# 1978 - 1980 Corvette: Service Bulletin: Instrument Cluster Area Squeak

**Subject:** Instrument Cluster Area Squeak

**Bulletin No:** 80-T-37

**Date:** May, 1980

CORVETTE INSTRUMENT CLUSTER LENS  
LOCATING TABS

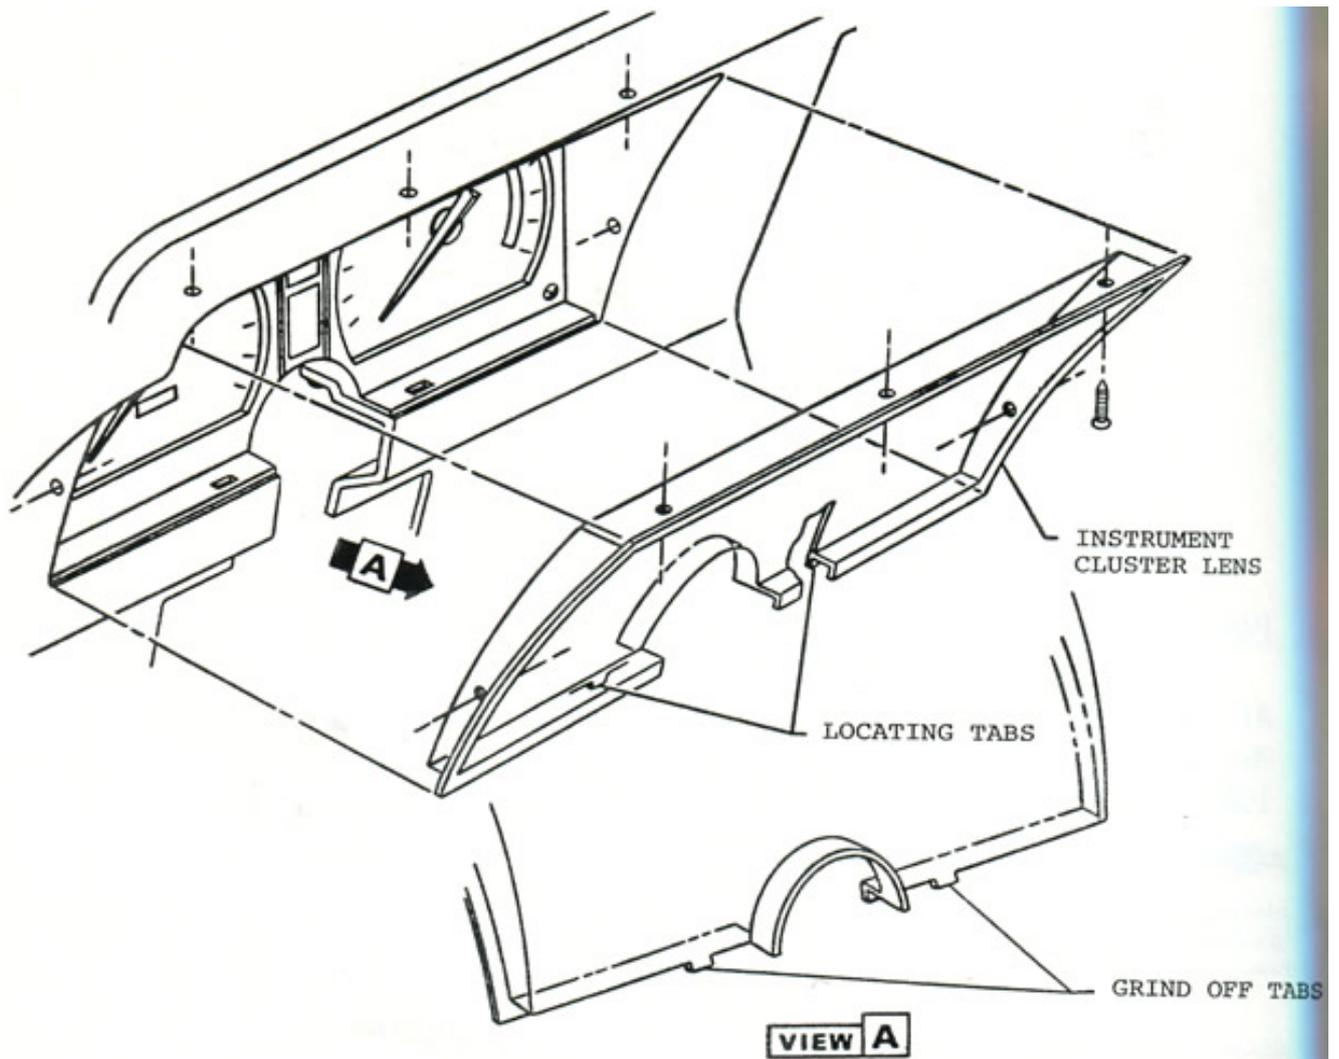
Lower tabs on cluster lens may rub against side of case locating holes. To verify this source, apply light hand pressure to lens.

Tabs will be removed from lens effective May 15, 1980.

1. Remove five (5) lens to case attaching screws and remove lens.
2. Grind off and file to a smooth surface the two (2) plastic locating tabs at bottom of lens, as illustrated on Page 2. CAUTION : The plastic lens is brittle and may crack if the tabs are snapped off rather than ground.
3. Reinstall lens to case with five (5) screws.
